DELEGATED APPLICATION REPORT

SITE ADDRESS: Alexander House 205-207 Kings Road Reading RG1 4LS

APPLICATION NUMBER: PL/25/0985

PROPOSAL: Change of use from Class E (offices) to Class C3 (dwelling houses) at part basement floor level to comprise 6 residential units and cycle parking. Prior Notification under Class MA, Part 3 of Schedule 2 of the Town and Country Planning (General Permitted Development) Order 2015 (as amended).

Image 2

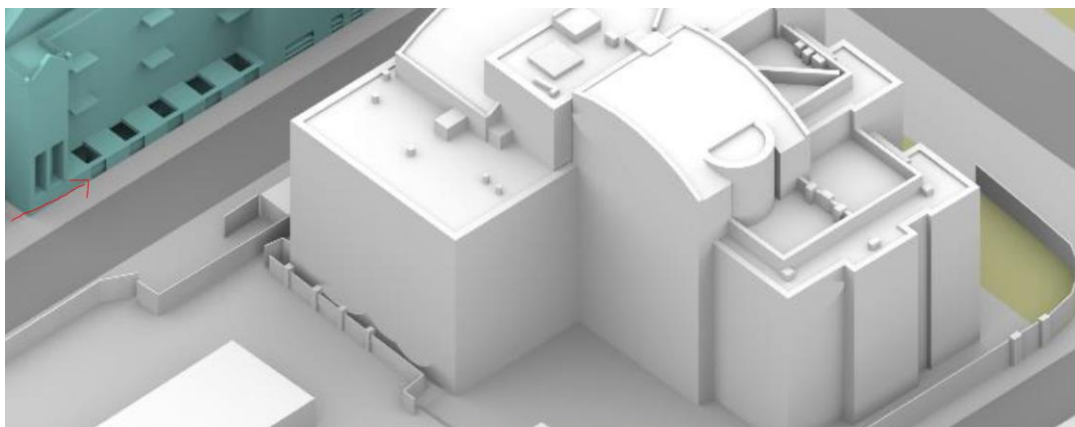
8.53 Image 2 at page 11 of the Internal Daylight and Sunlight Report (extract below) indicates some form of opening on the Rupert Street façade of the building, in line with the separate rooflights, to serve proposed Flats 1 & 2. However, this does not correspond with the equivalent 3D view at Appendix 2 of the report (extract below), or the elevation/floor plan submitted with the application, where no openings are shown at these points, only rooflights. This calls into question whether the assessment has been based on more window openings than are actually proposed in a separate 'operational development' application.

Extract of Image 2 at page 11 of the Internal Daylight and Sunlight Report – marked up with a red arrow to show the five openings on the Rupert Street façade

Extract of page 19 of the Internal Daylight and Sunlight Report, with the proposed 3D view in Appendix 2 not showing any openings on the façade, unlike page 11

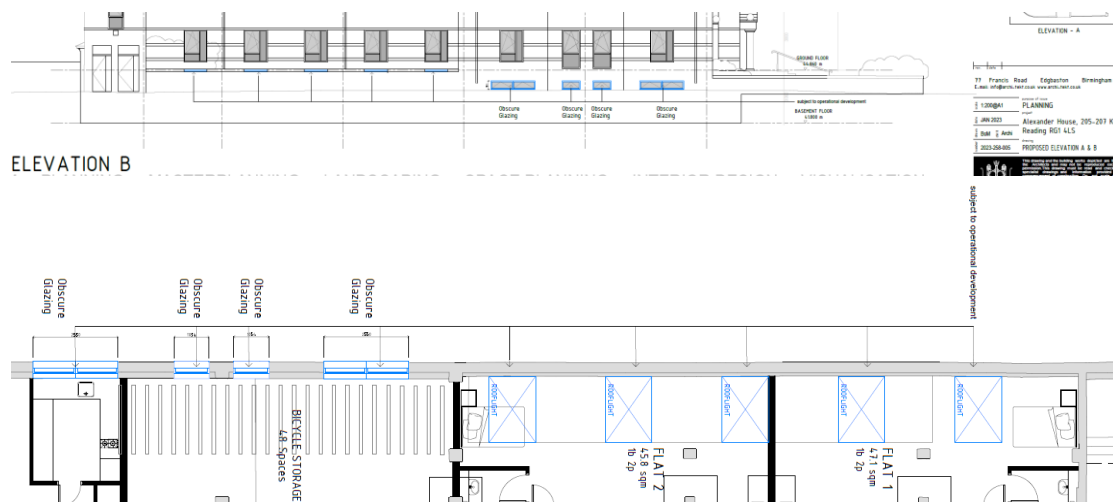
Extracts of floor plan and elevation plans submitted, which do not show any openings on the façade, only rooflights, serving proposed flats 1 & 2.

Image 4

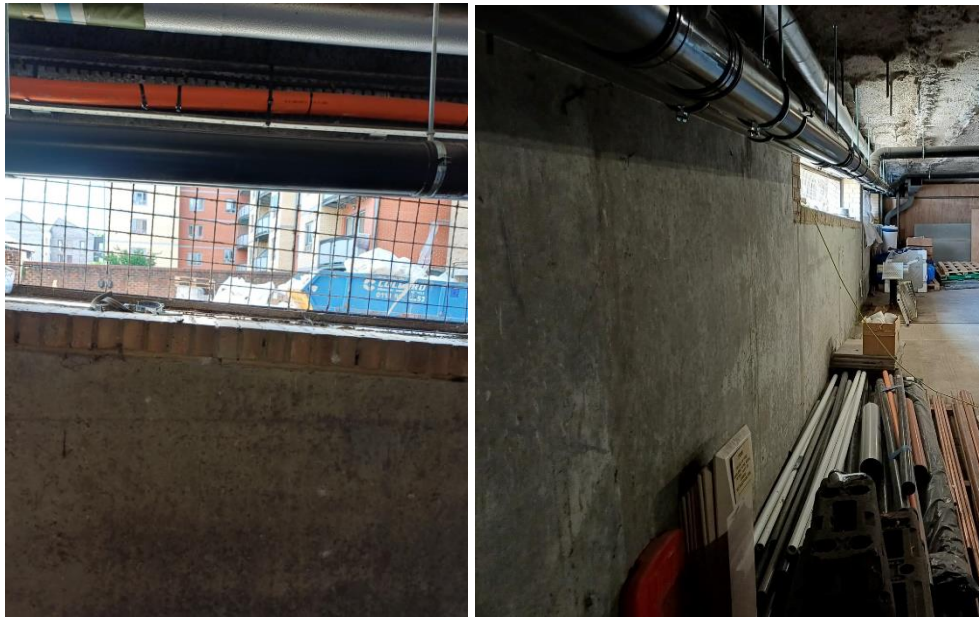
8.54 Whilst it is acknowledged that the Planning Statement quotes paragraph 7.4 of the Internal Daylight and Sunlight Report states all structural features of the building are taken into account, it is unclear why image 4 (shown below) only shows pillars and internal walls and not all elements as witnessed during the officer site visit on 05/08/25, such as the existing pipework directly in front of

the existing openings serving proposed Flats 4-6, as shown in the photographs below.

7.4 We can confirm that our model captures all the structural features of the building, including internal pillars, supports, ducts, internal walls, etc. and the rear entrance in front of unit six (which can be seen in image 3 above). We have included some images in Appendix 1 taken from our model which show the internal rooms in the building including the pillars and internal walls. The pillars and walls can also be seen on the 2D plots in Appendix 2; please see the annotated image 4 below.

Photos showing pipeworks in front of existing openings of proposed Flats 4-6.

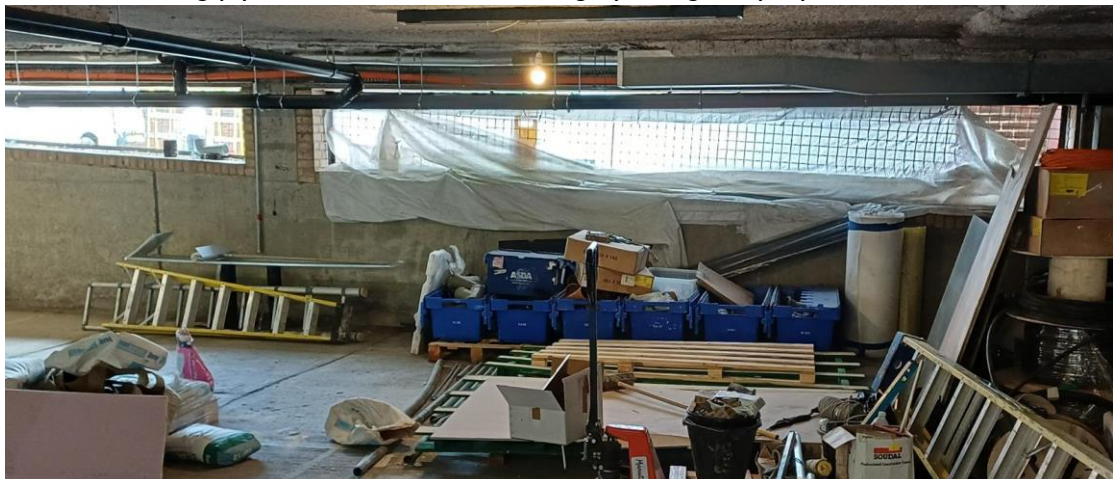
8.55 The developer has provided insufficient information to enable the authority to establish whether the proposed development complies with the standards. It is still questioned whether the methodology is robust in terms of taking into account obstructions. For example, if these pipes were to remain or be boxed in, this would limit the floor to ceiling height of the unit, which may in turn limit the light levels within the flats, noting the length of these windows are 1.4m.

Elevation A - no indication of the rooflights serving proposed Flat 3

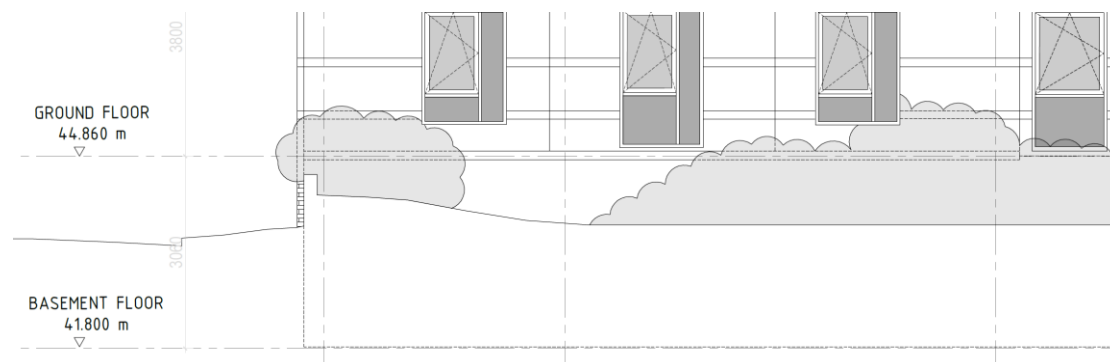
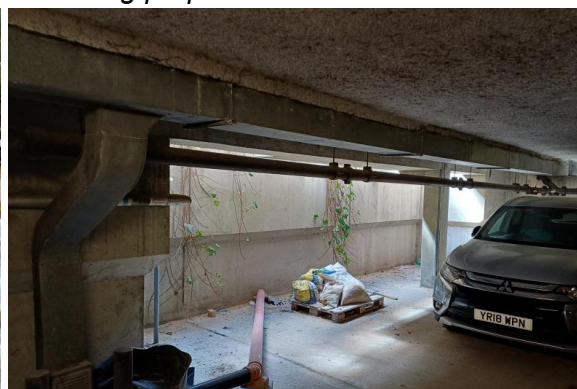
8.56 There is no indication on the plans submitted where the rooflights serving proposed Flat 3 are positioned. No information is stated on the elevation plan (extract below) and no section plan has been provided. The lightwell includes a raised surround, meaning that if the glazing were positioned away from the flush point, given the significant depth and small size of the lightwell, the surround could impact on the amount of light received within the subsequent room. Accordingly, the methodology followed by the applicant is unclear, meaning the developer has provided insufficient information to enable the authority to establish whether the proposed development complies with the standards.

Photos showing the raised surround of the lightwell (left) & basement level (right).

Extract of 2023-258-002 Block Plan, showing the balconies & intended rooflights.

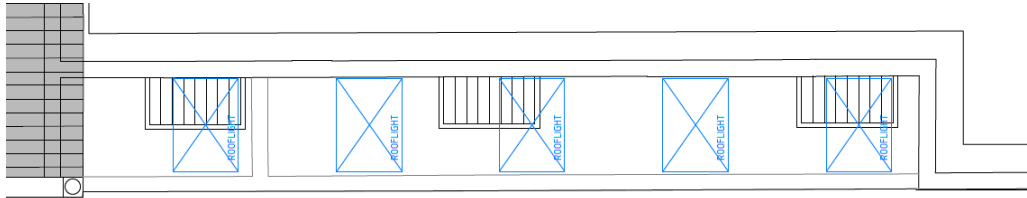
8.57 The block plan submitted with the application shows the existing balconies in the context of the separately proposed rooflights, which would serve Flats 1

Extract of Appendix 1 Proposed 3D View p3796/01 Rev 06, where the location of the rooflights does not align with those shown on the block plan above.

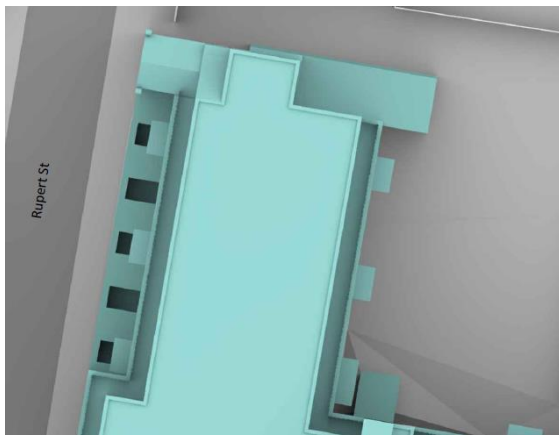
and 2. However, these do not align with the positions shown at Appendix 1 of the Internal Daylight and Sunlight Report (page 17). The position of the balconies is likely to impact on the amount of light reaching these rooms, so it is unclear whether the report is based on accurate information. Again, this means the methodology followed by the applicant is unclear, meaning the developer has provided insufficient information to enable the authority to establish whether the proposed development complies with the standards.
